**TOWN OF BAY HARBOR ISLANDS
PLANNING AND ZONING BOARD**

May 3, 2016

Subject: Site Development Plan Application
Request for Modifications to 2/3/15 PZB Approved Plans
1150 100th Street Townhouses – 4 DU Residential Complex
1150 100th Street
Bay Harbor Islands Acct. No. BP2015-467
MMPA Acct. No. 01-0702-1002

RE: CASA VERDE at Bay Harbor Islands, a Condominium
1140 – 1150 93 STREET, Bay Harbor Islands
NARRATIVE OF P&Z SUBMITTAL REVISIONS

A-1

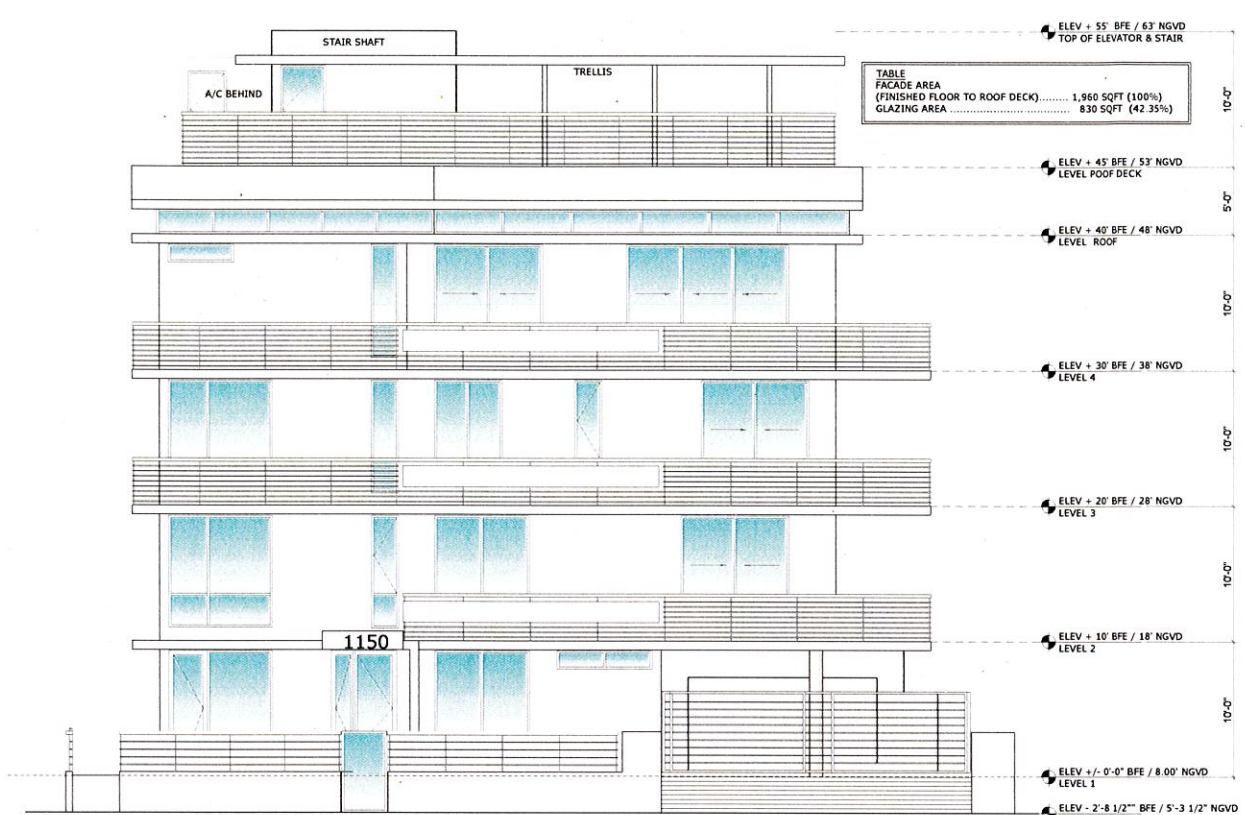
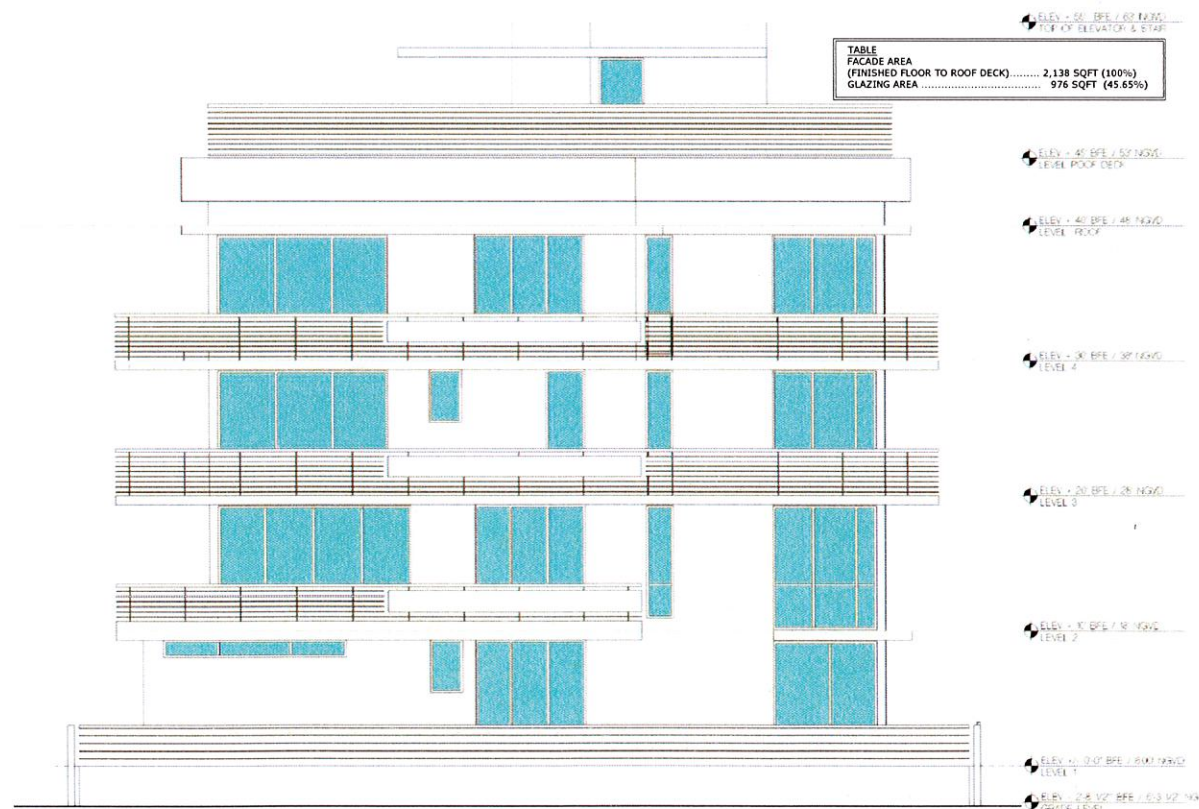
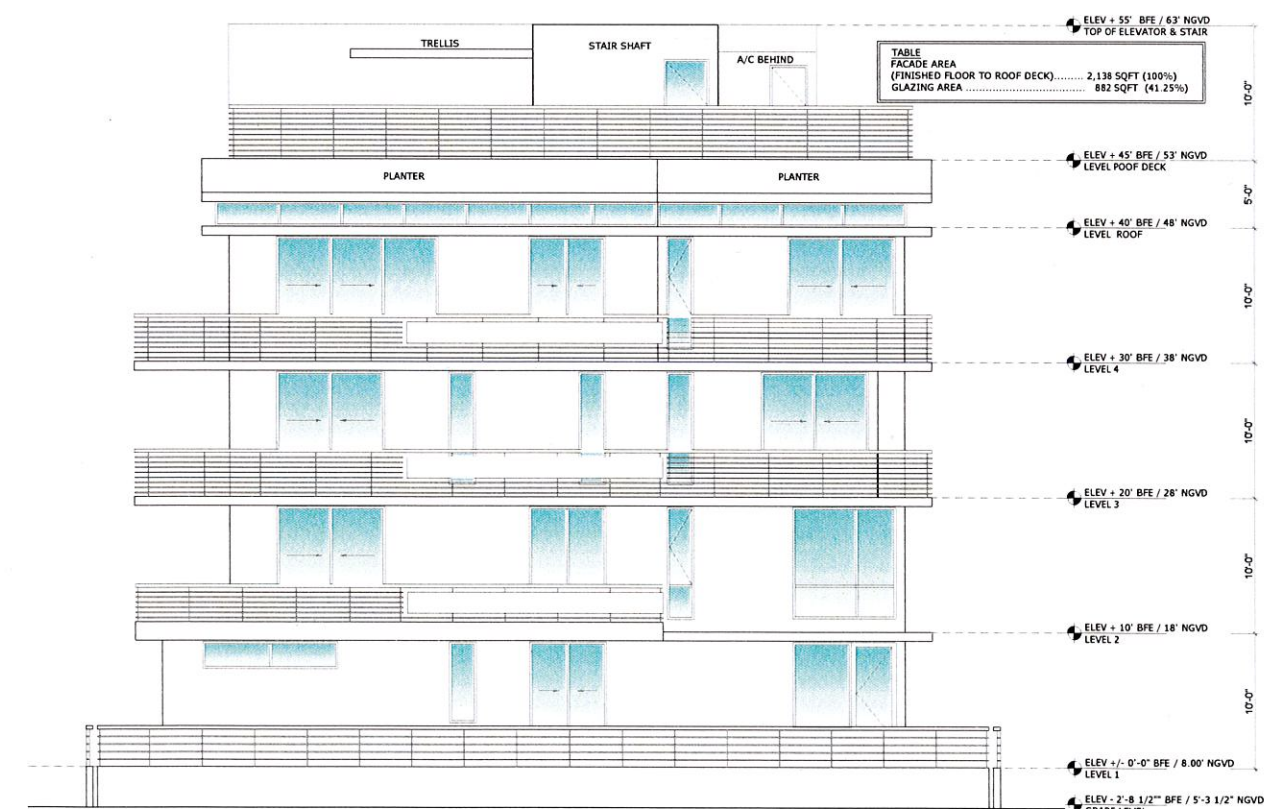
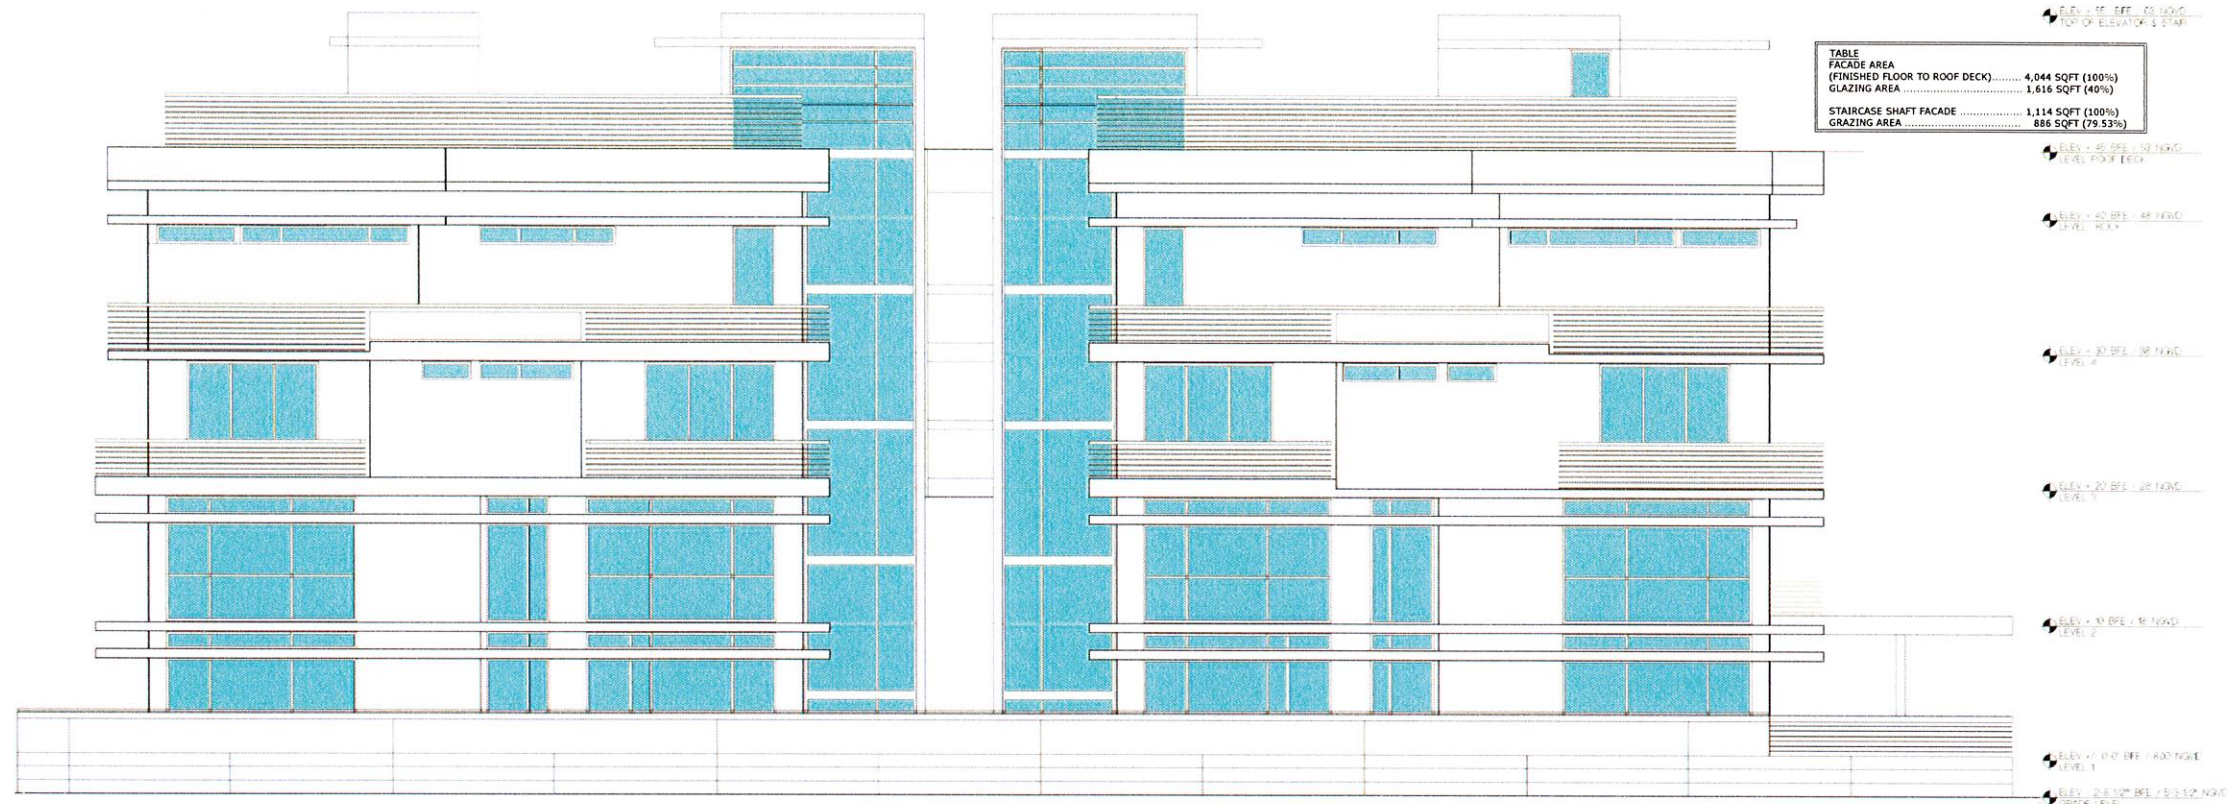
Elevations – The applicant is requesting to alter the windows (size / location / quantity) on all of the elevations and several eyebrows at the first and second level, which differs from the approved PZB plans. It should also be noted that condition "G" of Resolution No. 2044 (PZB approval) required the applicant to increase the glazing on the master bathroom located on the 4th floor (East Elevation). It appears this was not addressed on the revised plans.

Condition "I" of Resolution No. 2044 stated that the wall surface on the fourth floor (above the eyebrow and below the roof) shall consist of glazed glass (of like material as the windows) or a metal panel. The applicant has met this condition.

Condition "F" of Resolution No. 2044 stated that the entry canopy shall be lowered to just above the door or to the first eyebrow (that is presently shown below the entry canopy). The applicant has also met this condition.
